Bountiful City Administrative Committee Agenda Monday, October 27, 2025 3:00 p.m.

# **Administrative Committee Staff Report**

**Subject:** Conditional Use Permit for a Detached Accessory Dwelling Unit at

685 East 1825 South

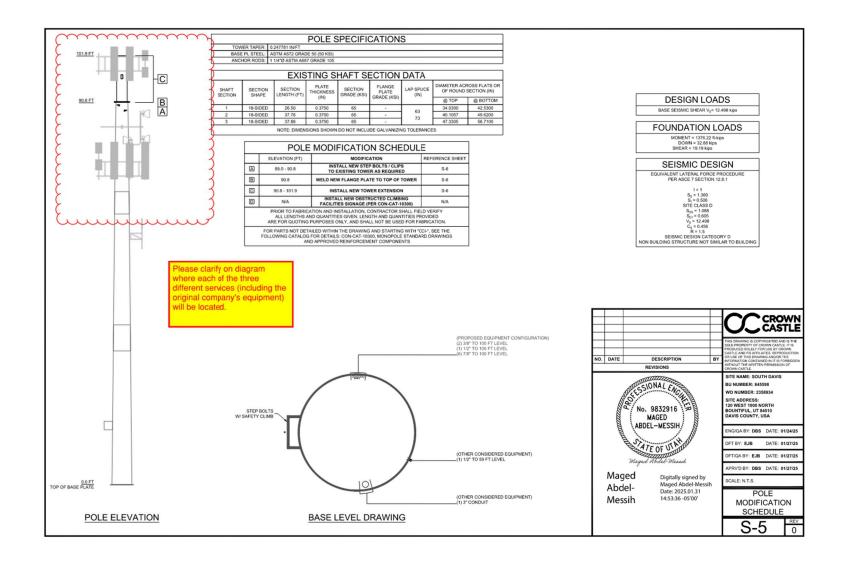
I sent a message through the City Inspect portal for application PLANCUP25-027 120 West 1000 North. The Planning Department needs more clarification about the location of each of the three different services on the pole being modified (including the original company's equipment). See the attachment sent on 8/11/25 for the redline notes.

The applicant must provide documentation showing that the tower was built to support three providers (the original company plus two co-locations). No record has been found confirming this requirement was met when the tower was first built.

To confirm this was only ran for 2 collocations, which is the only proposed collocations for the modification to the tower. I'm not seeing any additional comments in the portal outside of the structural related comments. Please let me know if we are missing anything else here.
